City of Biddeford

Planning Board

February 02, 2022 6:00 PM Zoom: Feb 2, 2022 06:00 PM Eastern Time (US and Canada)

- 1. DECLARATION OF QUORUM/VOTING MEMBERS**
- 2. ADJUSTMENTS TO THE AGENDA**
- 3. PLANNER'S BUSINESS**
- 4. CONSENT AGENDA**
 - 4.A. Approval of Meeting Minutes of January 19, 2022
[PB Minutes 011922-DRAFT.pdf](#)
 - 4.B. Approval of Meeting Minutes of January 26, 2022
[PB Minutes 012622 Workshop-DRAFT.pdf](#)
- 5. UNFINISHED BUSINESS**
- 6. NEW BUSINESS**
 - 6.A. 2022.01 Conditional Use Permit & Shoreland Zoning Permit for The City of Biddeford for Replacement of a Pump Station at 432 Main St. & 20 Horrigan Ct (Tax Map 34, Lot 16 & 16-1) in the B1 & GD-2 Zones.

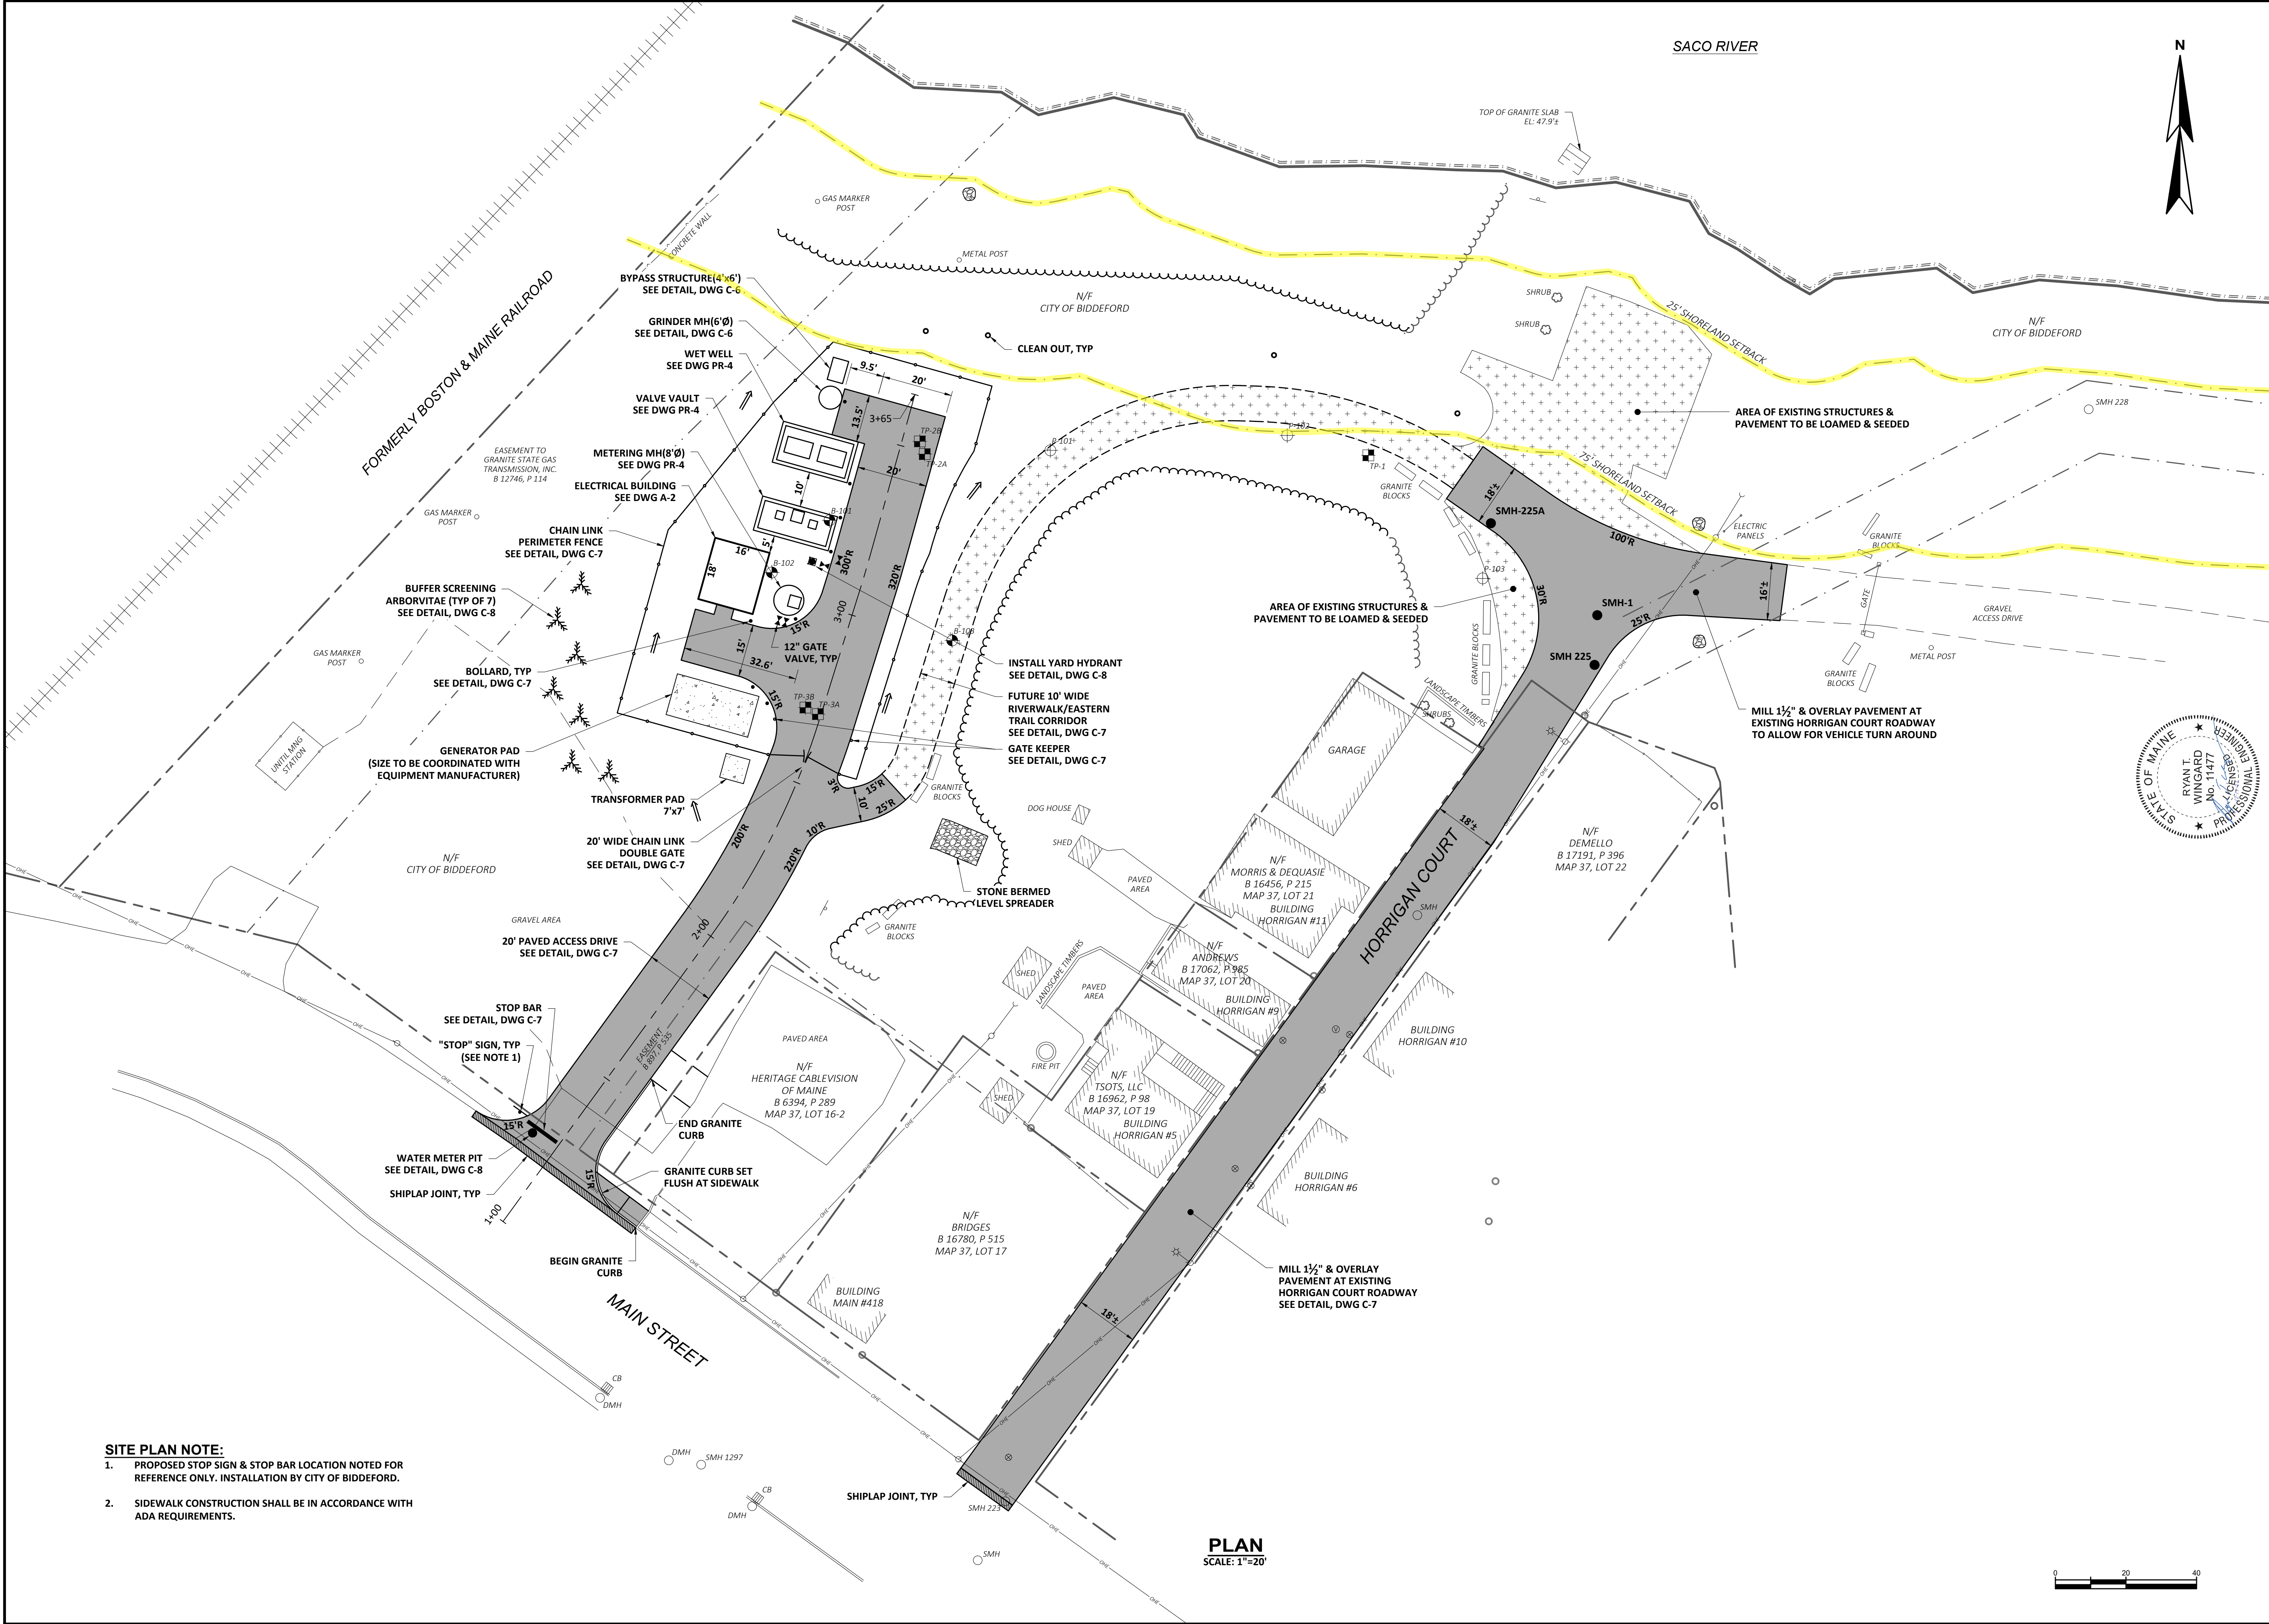
- 1. *Site Plan Note #2 on Drawing C-3 requires the contractor to bring all sidewalks into ADA compliance. A flush curb accessible ramp is shown on the east side of the pump station road. Linework for a tactile warning strip and an applicable callout will be added to Drawing C-3 in this location.*

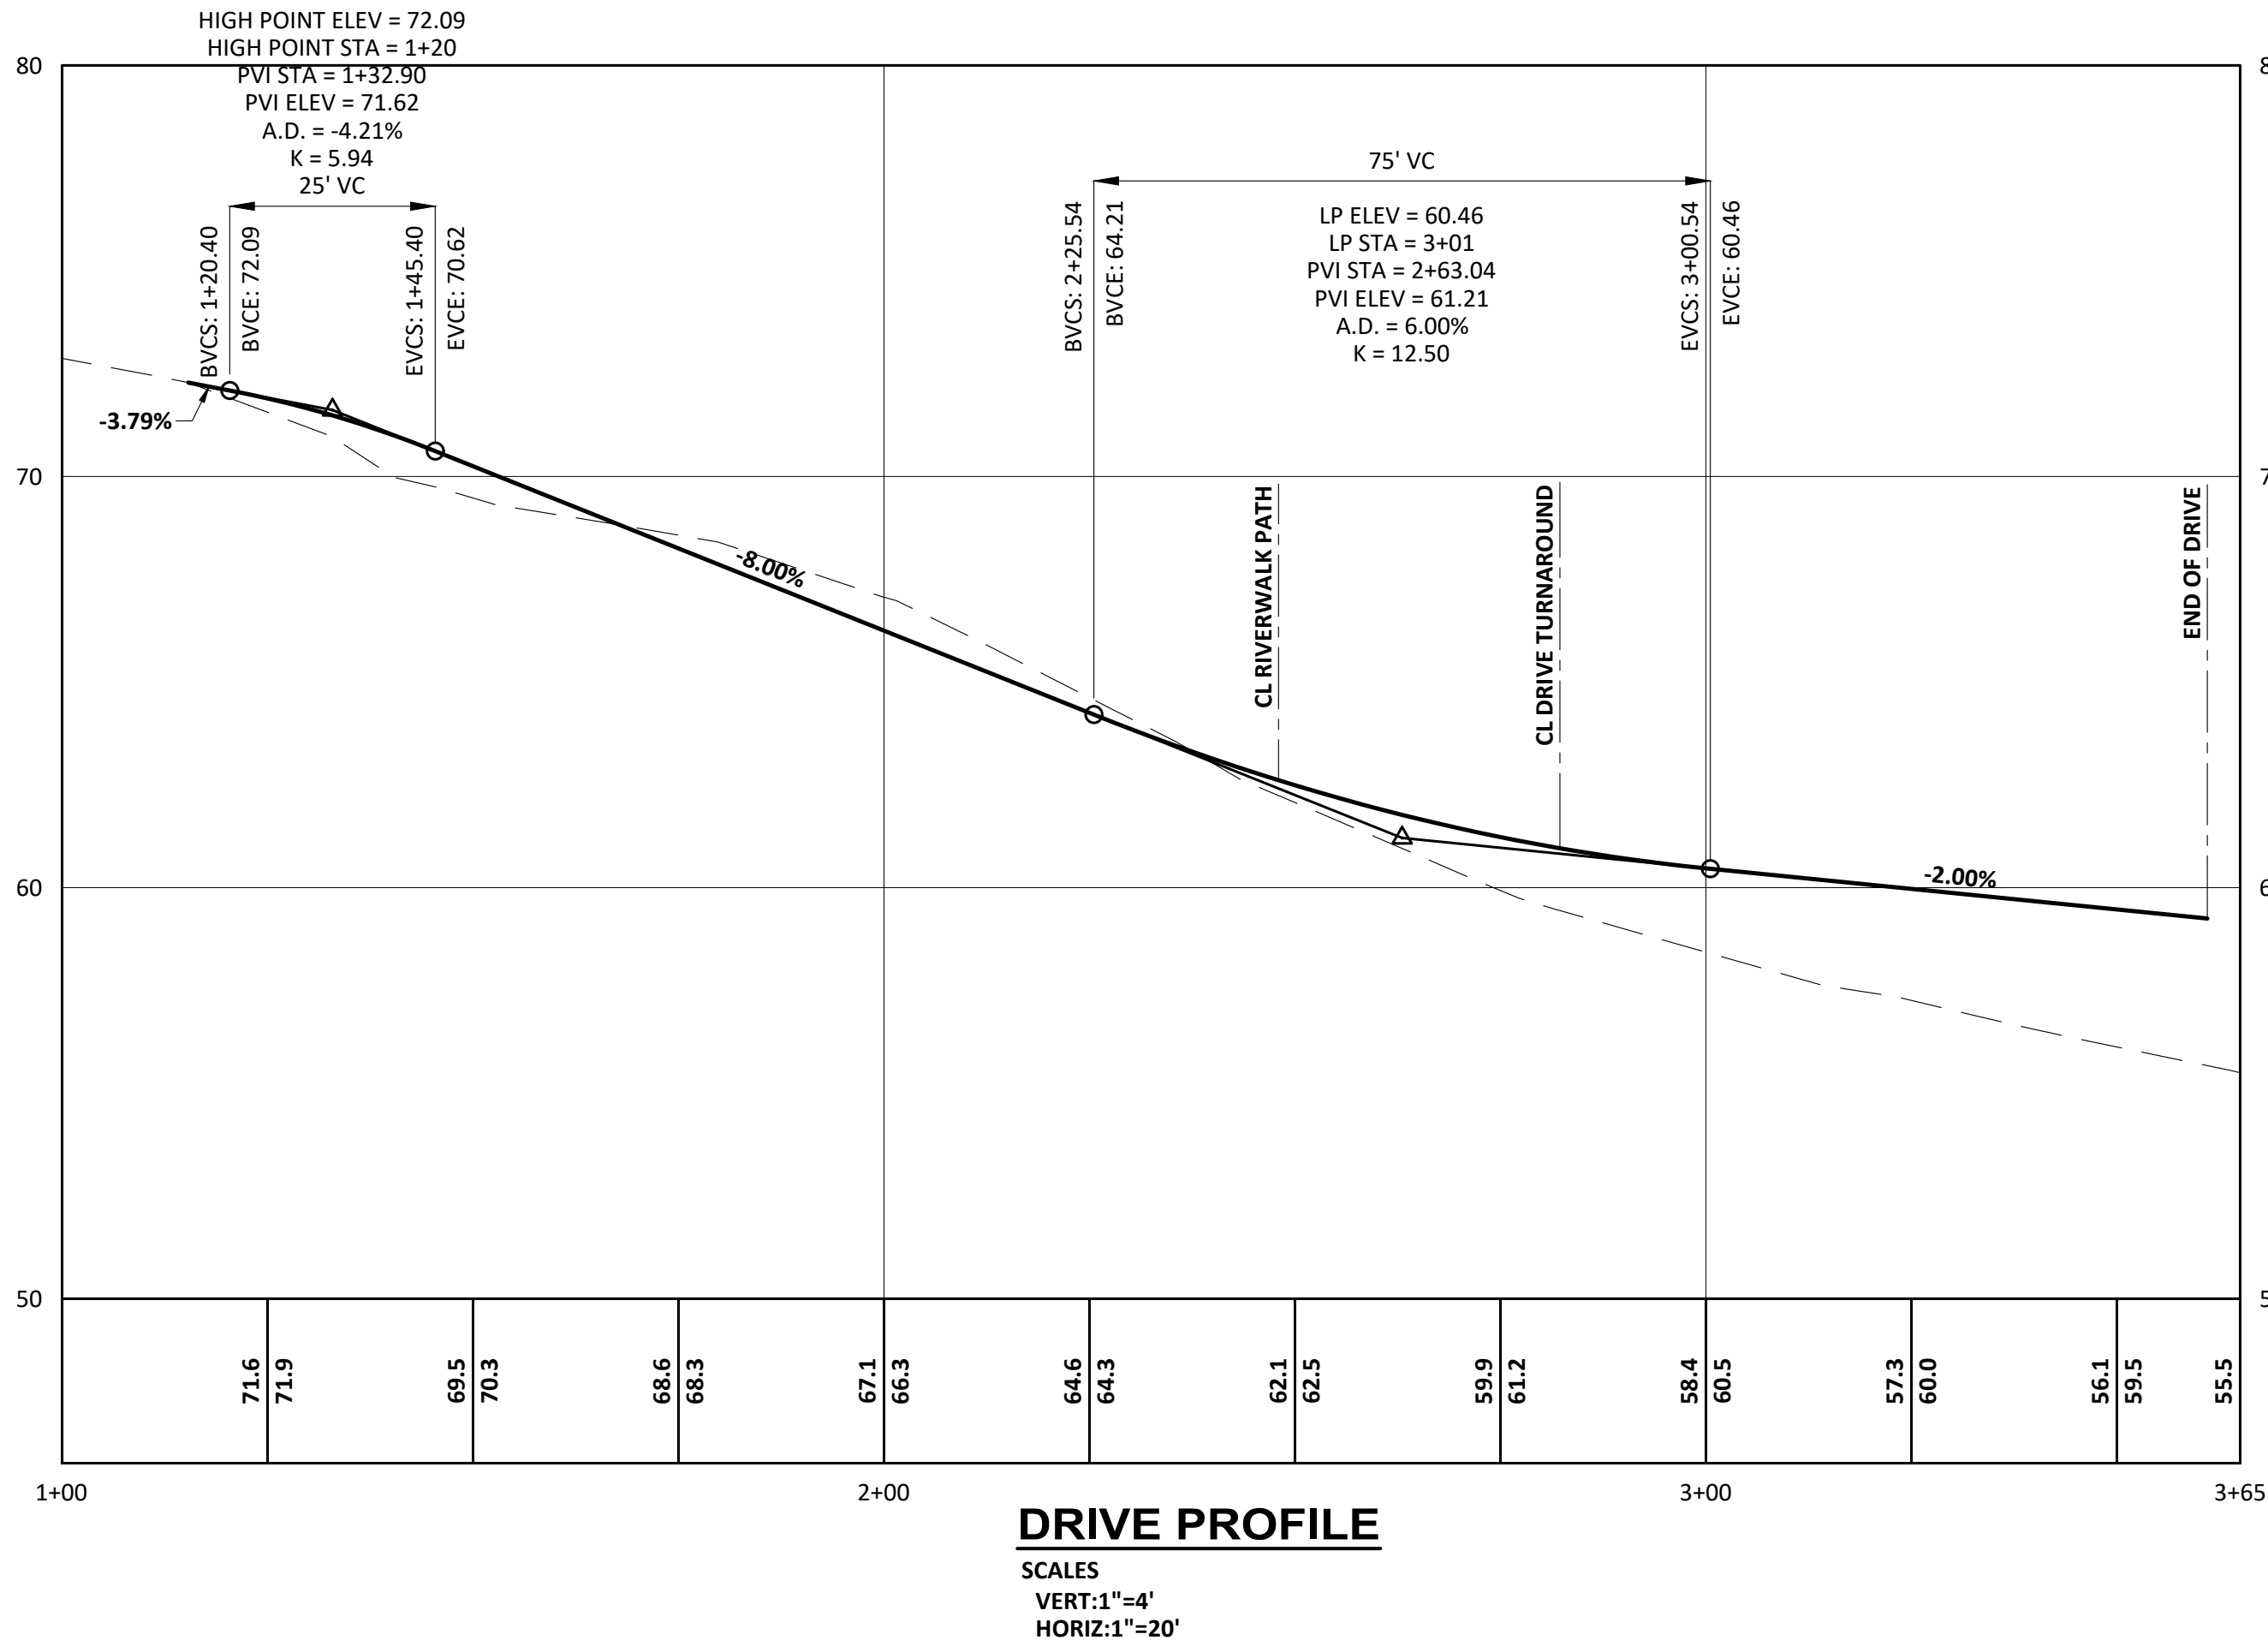
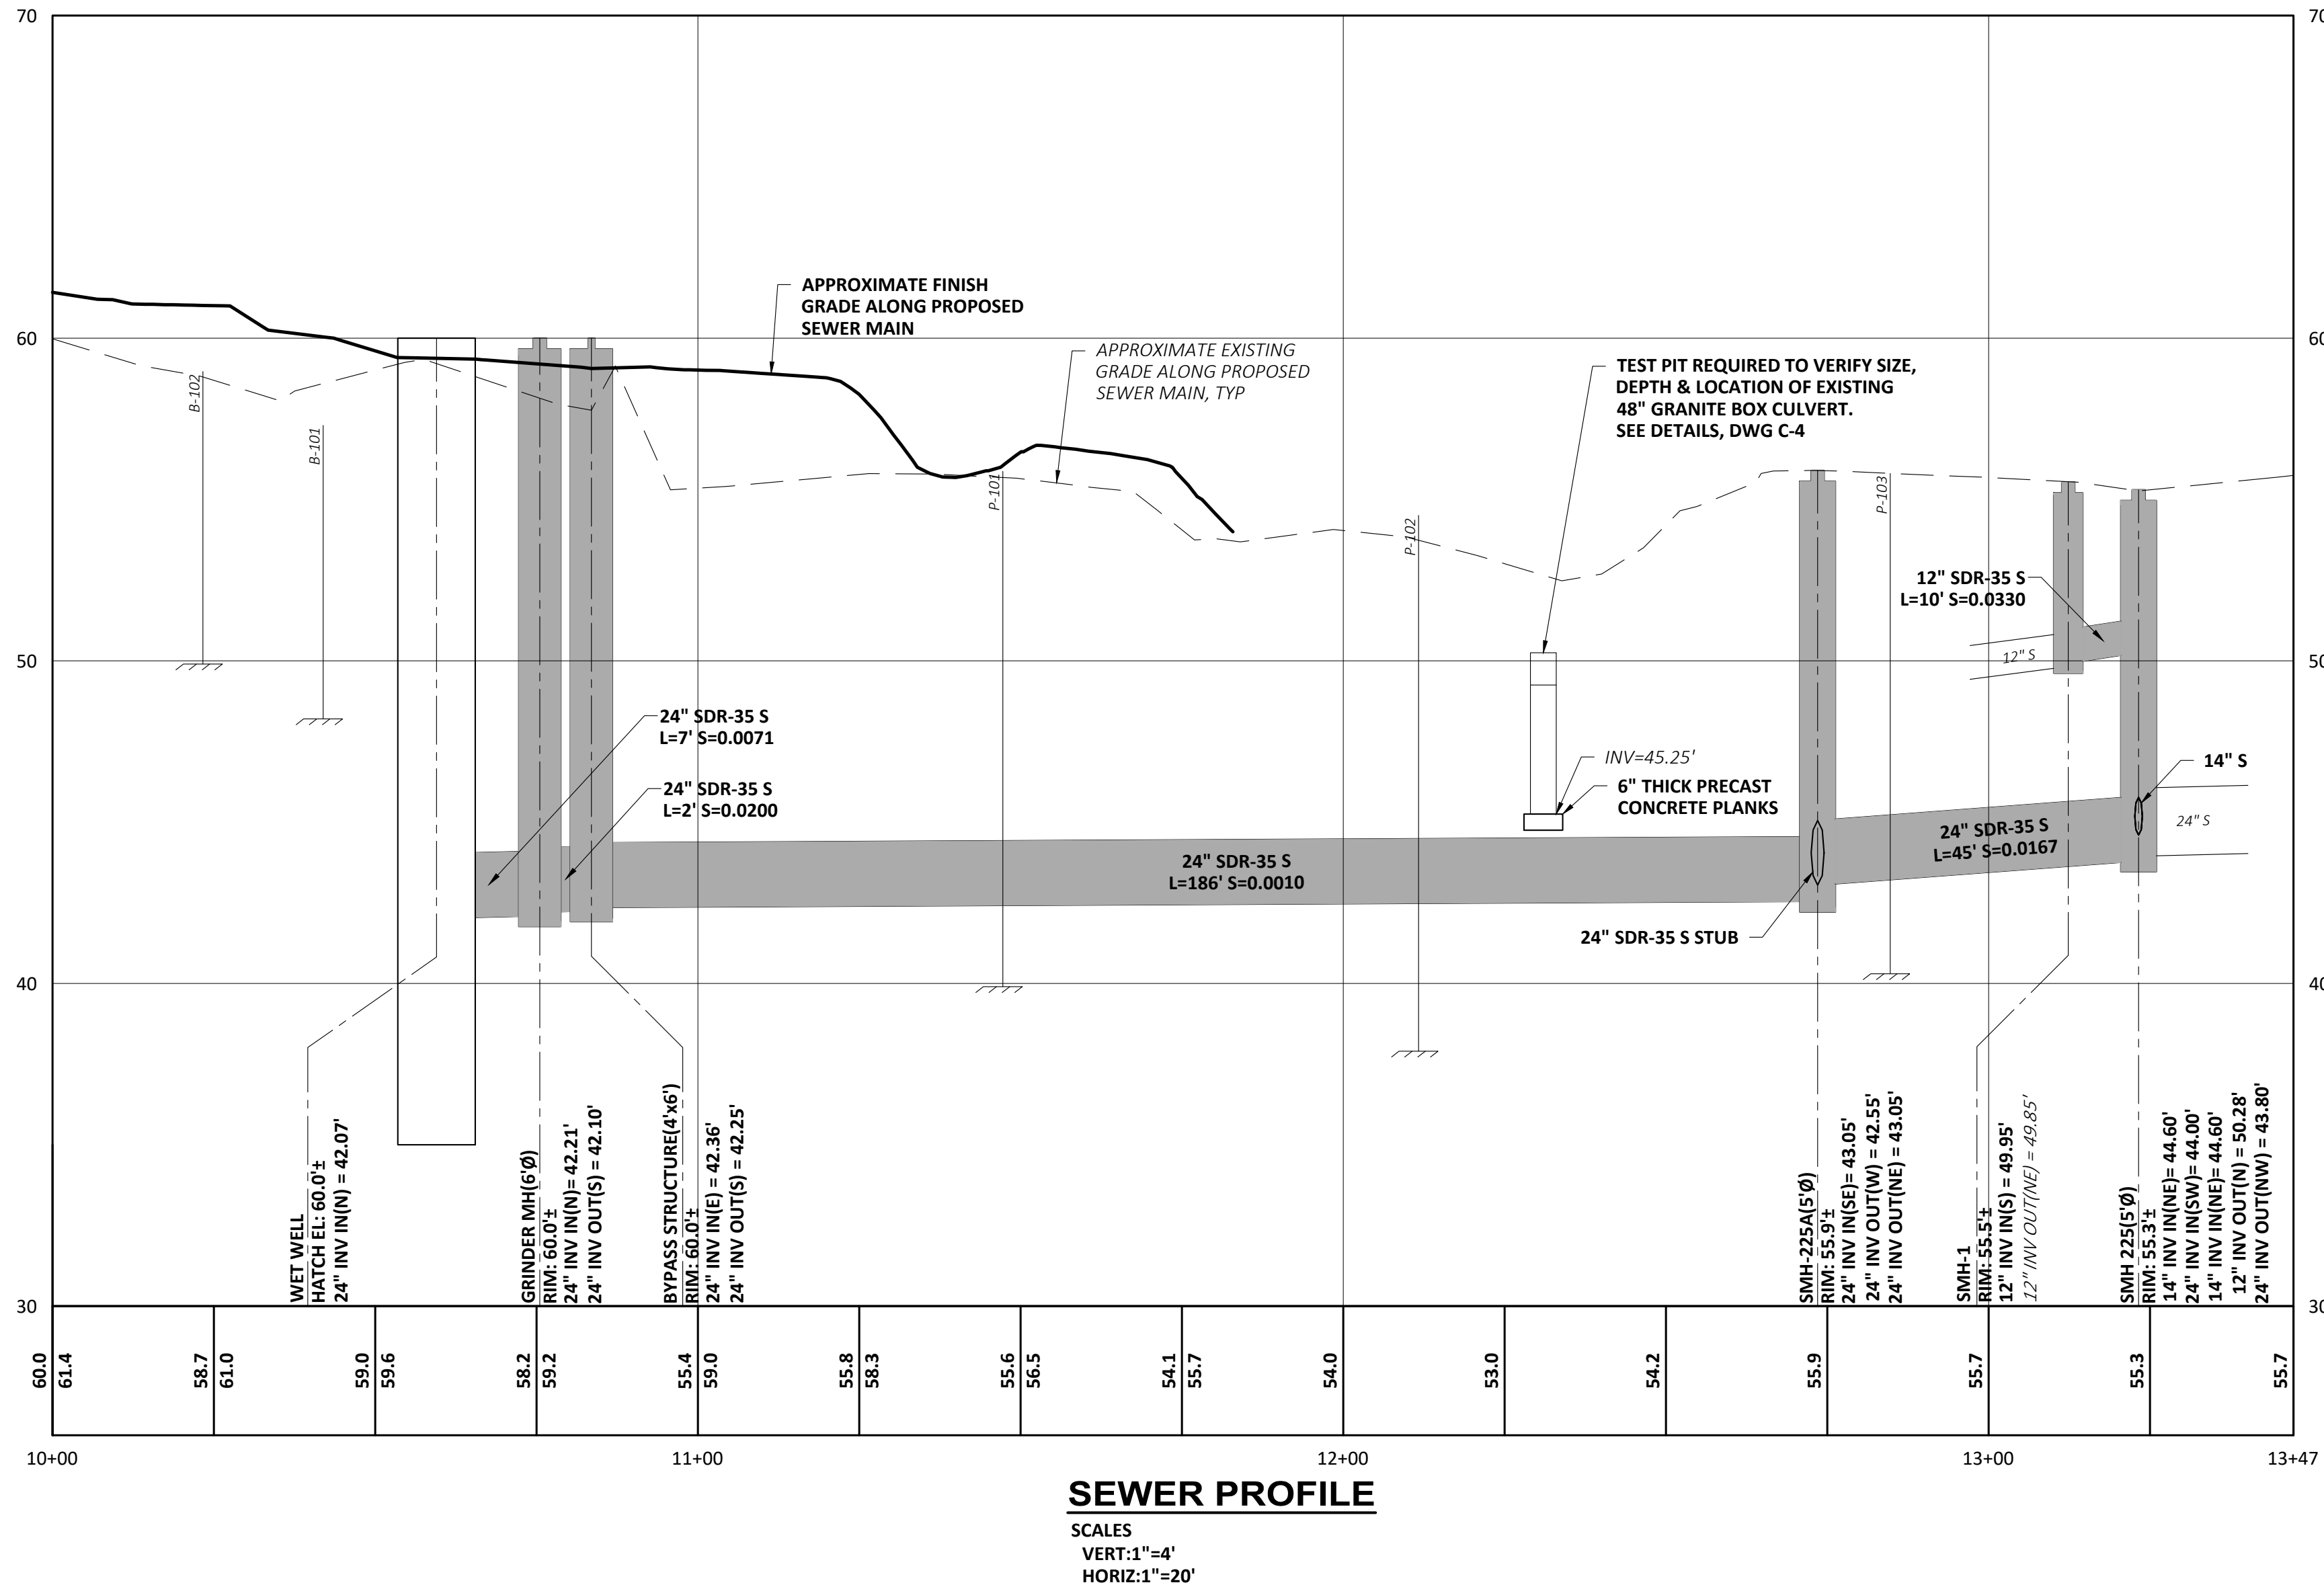
1. Add a signature block to sheet C-4 akin to the following:

- b. Plans must be updated to reflect Shoreland Zoning setback requirement of 100 ft, instead of 75 ft which is currently shown on the plan.
 - c. Add a City Planner signature block to Sheet C-4 and submit final plans addressing all identified outstanding issues for review and signature. The approved plans must be recorded at the York County Registry of Deeds.
